**UNITED STATES
NUCLEAR REGULATORY COMMISSION
ADVISORY COMMITTEE ON REACTOR SAFEGUARDS
WASHINGTON, DC 20555 - 0001**

SUBJECT: CERTIFICATION OF THE MINUTES OF THE ACRS
 ARP1400 SUBCOMMITTEE MEETING ON OCTOBER 4,
 2016, IN ROCKVILLE, MARYLAND

SUBJECT: CERTIFICATION OF THE MINUTES OF THE ACRS APR1400
SUBCOMMITTEE MEETING ON OCTOBER 4, 2016, IN
ROCKVILLE, MARYLAND

ADVISORY COMMITTEE ON REACTOR SAFEGUARDS
APR 1400 SUBCOMMITTEE MEETING

Figure 1

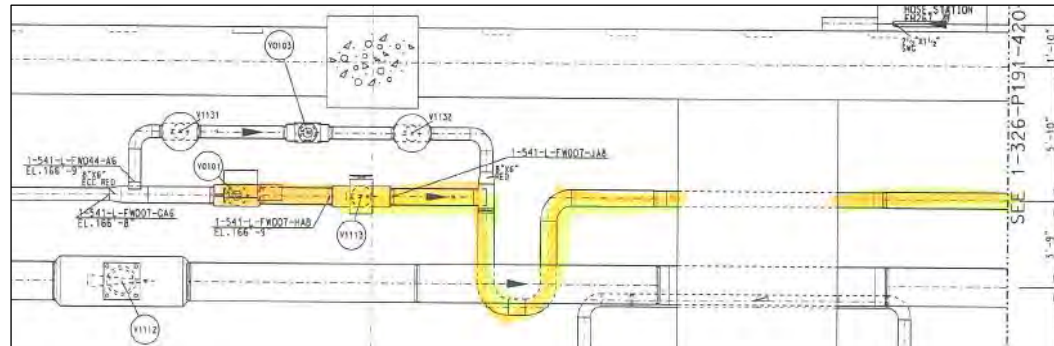
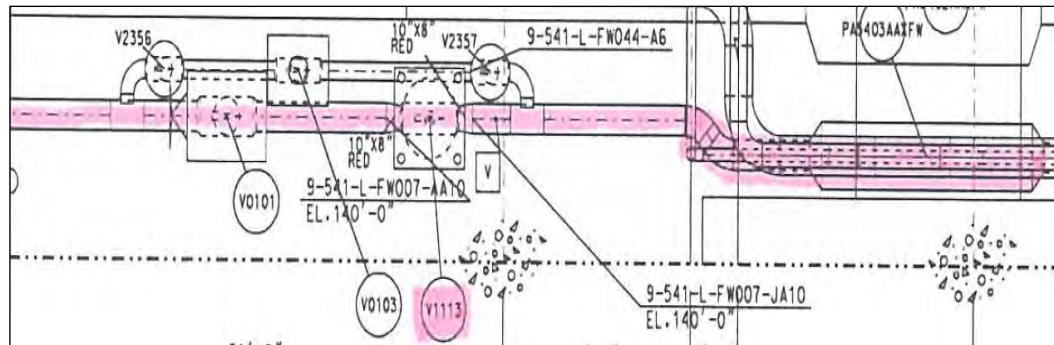
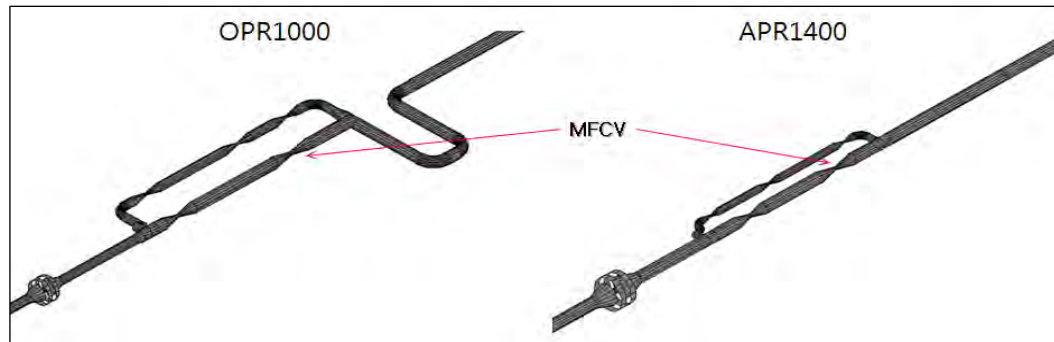
19 My answer is like this sentence. In
20 OPR 1000 design, chrome-moly steel is utilized
21 between the main feedwater control valve and the
22 main steam air valve house, right, which contains
23 sharp bending portions susceptible to flow
24 accelerated corrosion, as shown in figure 1.

2 In the APR 1400 design, carbon steel is
3 utilized between the main fuel control valve and
4 the main steam valve house, right, which does not
5 have sharp bending portions, as shown in figure 2.
6 This slide shows figure 1, 2, 3. As you can see,
7 this figure 1 in OPR 1000 design, there is a sharp
8 bending portion, as you can see in this figure.
9 So, the rule I raised here was installed. On the
10 other hand, in APR 1400 design, there are no sharp
11 bending portions. So, we have changed the material
12 to carbon steel.

13 Figure 3 shows the three-dimensional
14 configuration between OPR 1000 and APR 1400 design.
15 This slide shows the material comparison between
16 OPR 1000 and APR 1400. As you can see with this
17 figure, these portions that were installed with
18 roll that are still in post-design, OPR 1000 and
19 APR 1400. On the other hand, this portion between
20 the main feedwater control valve to the main steam
21 valve house were installed with roll in just the
22 OPR 1000 design.

- Open Item 10.3.6-3 (RAI No. 8649, Question 10.03.06-26, Date issued (07/26/16); KHNP responded (09/29/16)
 - **Description of Issue** : The staff noted a configuration of: chrome-molybdenum steel to carbon steel to chrome-molybdenum steel in the downcomer line. This configuration is more susceptible to FAC as discussed in NSAC-202L Revision 3.
 - **Resolution** :
 - a. In OPR1000 design, chrome-moly steel is utilized between MFCV and MSVH line which contains sharp bending portions susceptible to FAC as shown in Figure 1. In the APR1400 design, carbon steel is utilized between MFCV and MSVH line which does not have sharp bending portions as shown in Figure 2. The 3D piping layout is presented in Figure 3 in line of between MFCV and MSVH comparing OPR1000 and APR1400 design.

Figure 4

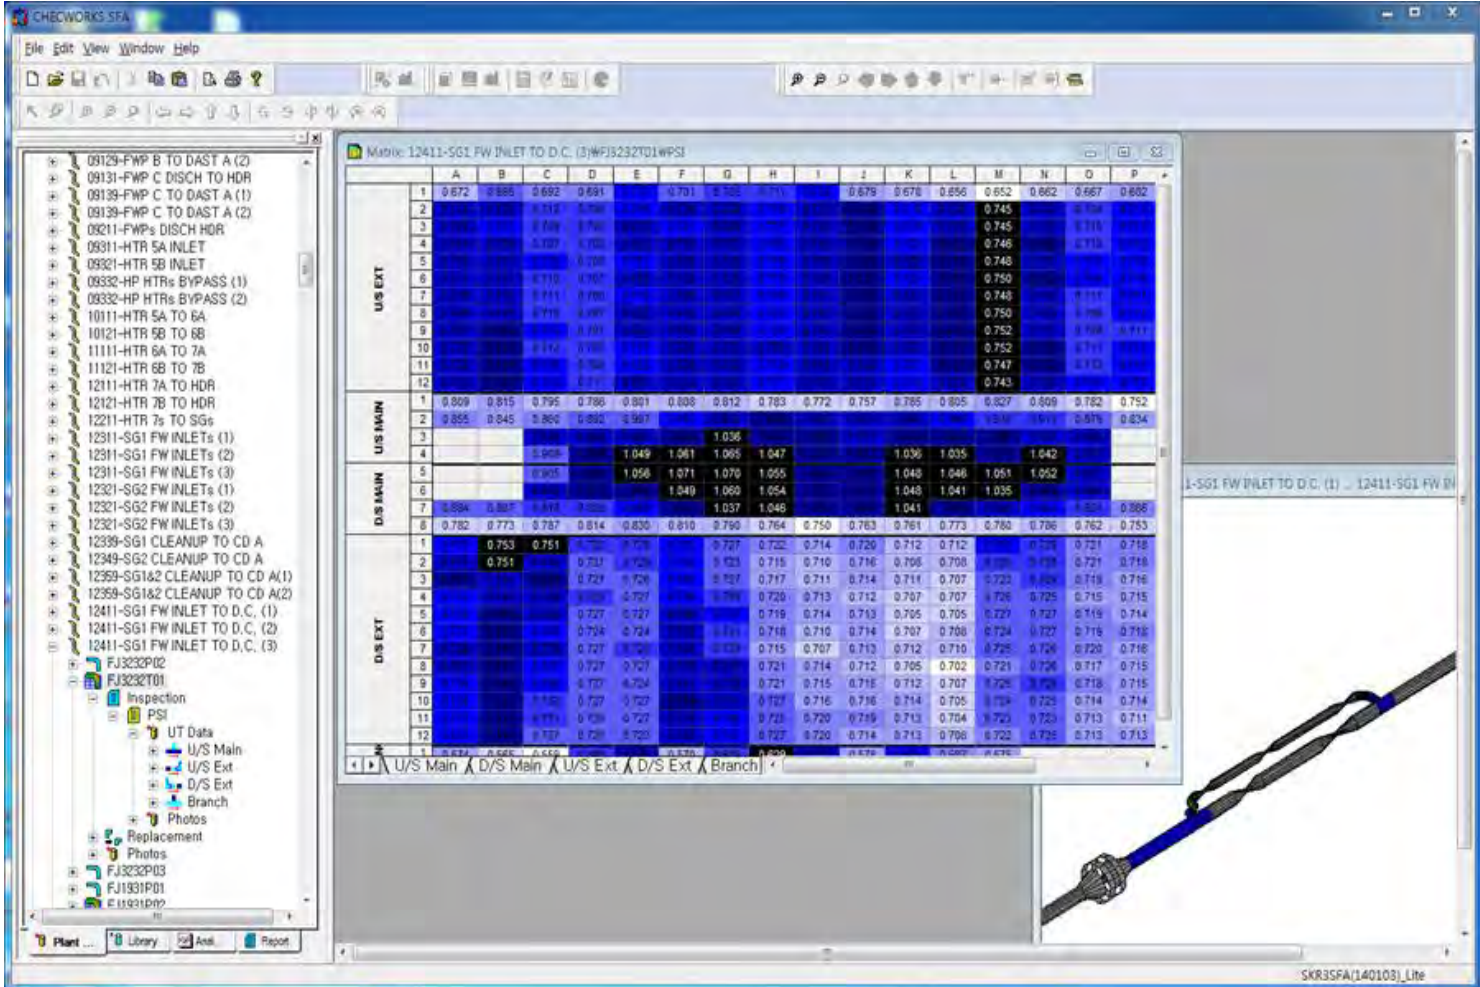
UT thickness inspection is performed to evaluate component wear beyond the toe of the weld. Initial wall thickness is taken in components placed downstream of the MFCV and will be inspected periodically during plant operation. Figure 4 shows the UT inspection data implanted to CHECWORKS which has been taken prior to the pre-operation.

- 10.4.8 Steam Generator Blowdown System – Open Item (1/1)

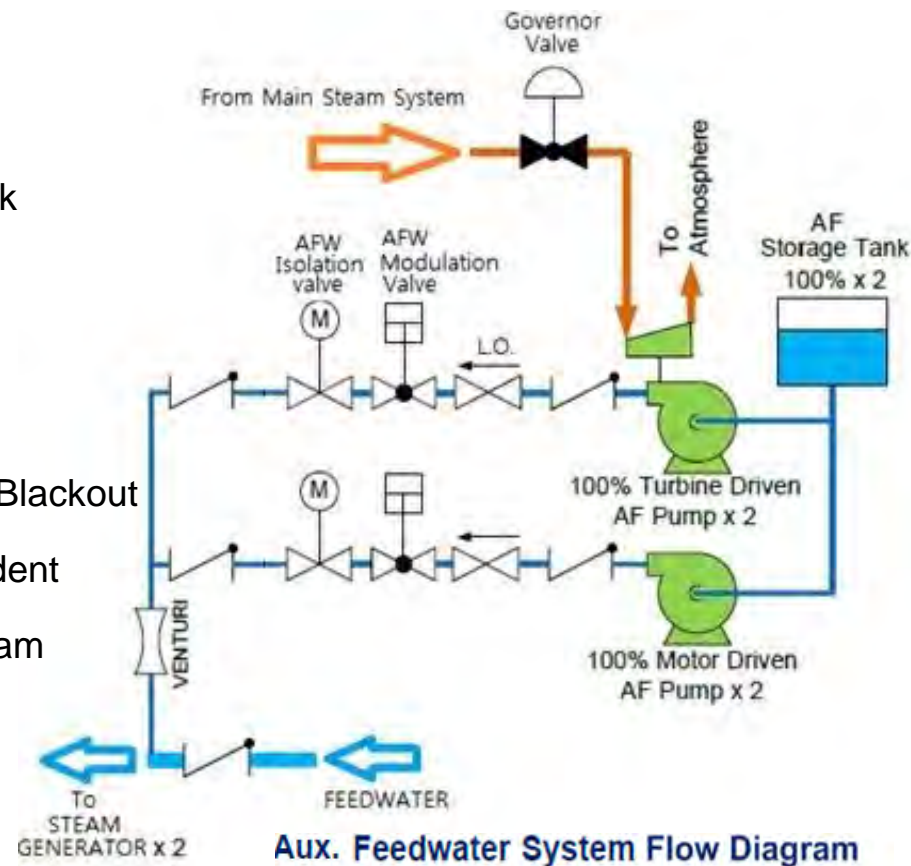
- Open Item 10.4.8-1 (RAI No. 8596, Question 10.04.08-6), Date issued (5/4/16); KHNP responded (8/8/16)
 - **Description of Issue** : Address the missing actuation signals (High Radiation Actuation Signal(HRAS) and Blowdown Flash Tank High-High Level Actuation Signal (BFTHHLAS) in DCD Figure 2.7.1.8-1 and to provide additional detail in DCD chapter 7 for consistency and clarity.
 - **Resolution** : Indicated the actuation signals (HRAS and BFTHHLAS) in DCD Figure 2.7.1.8-1 and provided the detailed description in DCD chapter 7 subsection 7.3.1.9.

- ♦ Revise Tier 1 Figure 2.7.1.8-1 to identify two additional control signals that activate CIVs in the SGBS. The applicant had proposed adding these control signals to the corresponding Tier 1 table but not to the figure. The two signals are:
 - High Radiation Activation Signal (HRAS)
 - Blowdown Flash Tank High-High Level Actuation Signal (BFTHHLAS)
- ♦ Provide a description in DCD Chapter 7 of the specific signals that activate the CIVs rather than a general description of instrumentation and control signals.

17 MR. J.W. CHOI: Yes. Our answer is
18 like this: indicate the actuation signal HRAS and
19 BFTHHLAS in DCD figure 2.7.1.8-1 and provide the
20 detailed description in DCD Chapter 7, Subsection
21 7.3.1.9.
